Planning and Zoning Board

GENERAL PLAN CASE#: GPMInor14-006
ZONING CASE#: Z14-017
LOCATION/ADDRESS: 3143 South Power Road
GENERAL VICINITY: Located south of Guadalupe Road on the east side of Power Road
GENERAL PLAN REQUEST: Minor General Plan Amendment to adjust the boundaries of the existing Mesa 2025 General Plan Land Use designations from NC and HDR 115+ to MDR6-10 (16.3± acres)
ZONING REQUEST: Rezone from LC and RM-4 to RSL-2.5 PAD and site plan/preliminary plat
PURPOSE: This request will allow the development of a single residence subdivision with 100 lots
COUNCIL DISTRICT: District 6
OWNER: Saia Family Limited Partnership
APPLICANT: Andy Ho, KB Homes
Sean Lake, Pew and Lake, PLC
STAFF PLANNER: Lesley Davis

This proposal includes a Minor General Plan amendment to change the existing land use designation for the 16.3± acres at 3143 South Power Road. The existing General Plan land use designation for the site is NC (Neighborhood Commercial) and HDR 15+ (High-Density Residential 15+ du/ac). The applicant is requesting an amendment to Medium Density Residential 6-10 (MDR 6-10 du/ac) to accommodate the development of 100 single residence lots.

The request also includes a rezoni

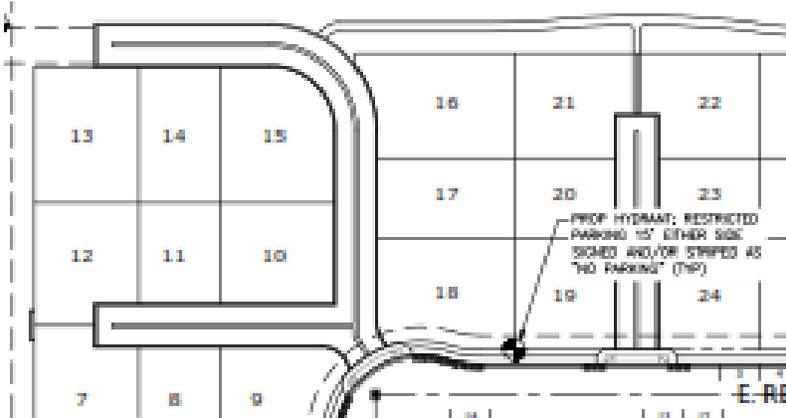
The applicant has exceeded the minimum number of elevations for the courtyard and number of plans for the development. Staff feels comfortable that there will be a variety in elevations and plans within the pod/cluster, however there is a significant concern that there has only been one plan provided (plan 2260,) that has been designed with the garage on the side to accommodate the lots along the public streets. There are 3 elevations for this plan; however the street scene will be consumed by those three elevations of that single house plan, which has a fairly substantial presence on the street as a two-story home with a reduced setback. This is a particular concern as you drive along the streets identified as Redfield and Olney Courts on the site plan below. The front elevations for plan 2260 have also been included below:

Staff is also concerned with the proposed architecture of the homes. The detailing on the elevations (materials, fenestrations, and covered patios) can have a significant impact on the long-term quality of the project to create architectural interest and street theming, and to retain value in the development over time. It is also important to note that these homes are located very near one another and movement in the buildings themselves becomes very important to avoid large 2-story masses, which could create a “canyon” effect in the private yard spaces and along the pedestrian areas in front of the homes. Staff feels that in addition to the front elevations, particular attention needs to be paid to elevations that along Power Road and adjacent to retention and/or open space areas as well as sides/rears that are adjacent to a public street. Staff is recommending that the elevations be reviewed by the Design Review Board with final approval from the Planning Director to ensure higher quality design.

10. Residential product to be reviewed by the Design Review Board with final approval by the Planning Director.
11. Provide a revised ramada design for the open space area that provides more architectural detail. Details to be approved by the Planning Director.

12. Provide an additional house plan for the lots adjacent to the public street to provide more variety in housing product. Details to be reviewed by the Design Review Board with final approval by the Planning Director.

Parking and Solid Waste

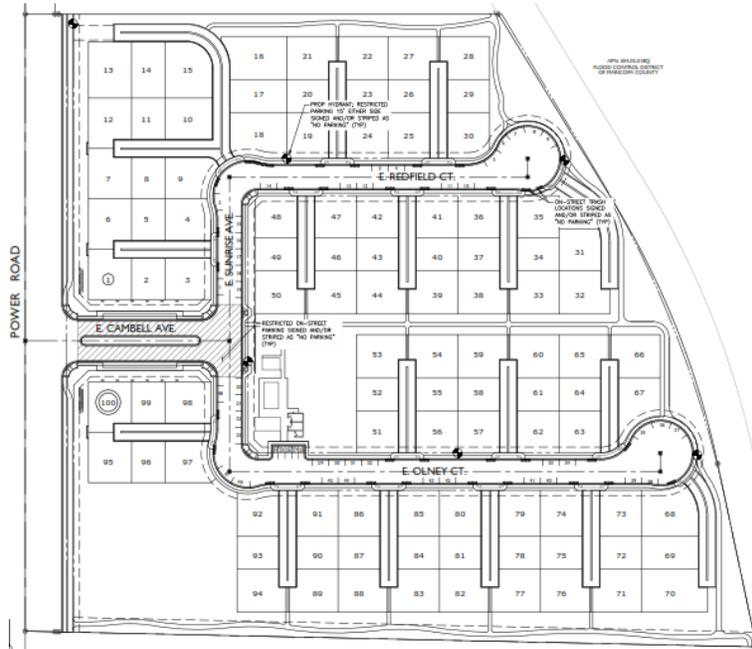
The applicant has provided 2 parking spaces within the garage unit and an additional 48 spaces on the looped public street as well as 18 parking spaces in private driveways for those homes further from the public street, which is 2.6 parking spaces per unit.

Historically, these types of developments generate a parking issue in the number of guest spaces provided. With a more traditional layout each home has parking in their garage, in their driveway, and in the street in front of their home. So, while only 2 spaces are required, there is typically parking for 4 – 6 vehicles with each home. In this type of development any visitor parking becomes parking along the street so that when people have social events parking can become difficult. This can be particularly problematic on Solid Waste pick-up days as well as holidays. The City of Mesa has not adopted separate development standards for “Garden Court” or “Motor Court” subdivisions; however some of the other jurisdictions have. Staff has been reviewing the City of Phoenix standards to help provide some

guidance in what may or may not be appropriate in our city for such a development. The Phoenix guidelines established a requirement for 3 parking spaces for each unit in the cluster with at least one space per unit being non-exclusive and located within 150-feet of the cluster. The proposed homes are a bit larger than what was previously supported at the 2.6 parking spaces per unit. These homes range from 1,600 to 2,260 square-feet with more of their homes in the 2,000 to 2,200 square-foot range. In homes of this size, there will likely be more residents who could potentially have vehicles and people are more likely to hold larger gatherings of people. This could create a parking problem in this subdivision. It is also a very isolated subdivision, so parking on a nearby street, in an adjacent neighborhood, will not be an option. Staff recommends that the applicant make revisions to provide a parking ratio that is more in line with 3 parking spaces per unit.

The primary concern for Solid Waste collection vs. parking spaces occurs in the northwest corner of the development, where there could be up to 9 barrels lined up on collection day. The applicant has provided a parking exhibit on page 58 of their design booklet that also identifies the locations of the barrels. Parking has not been shown in this area, but realistically, it will be difficult to police those areas to prevent parking along the street in that location. Another concern is the distance that a homeowner will need to roll their barrel from their home to the designated space on the public street. The most significant distance is for the lots at the northwest corner of the development. For instance, lot 13 would require a homeowner to take that barrel back and forth to the street approximately 300 feet, four times a week. This is more than twice as far as most of the homes within the subdivision. Staff recommends that the applicant make revisions to reduce the maximum distance for moving a barrel to 150-feet. The applicant has provided a parking plan that includes the on-street parking locations as well as the barrel locations on page 8 of the design booklet. Staff has included a blow up of this area below as well as the full graphic submitted by the applicant below:

19. Redesign of the lot layout in the northwest corner of the development to reduce the distance between the unit and the Solid Waste barrel location on the street to no more than 150-feet.

20. Provide a parking ratio of three (3) parking spaces per dwelling unit.
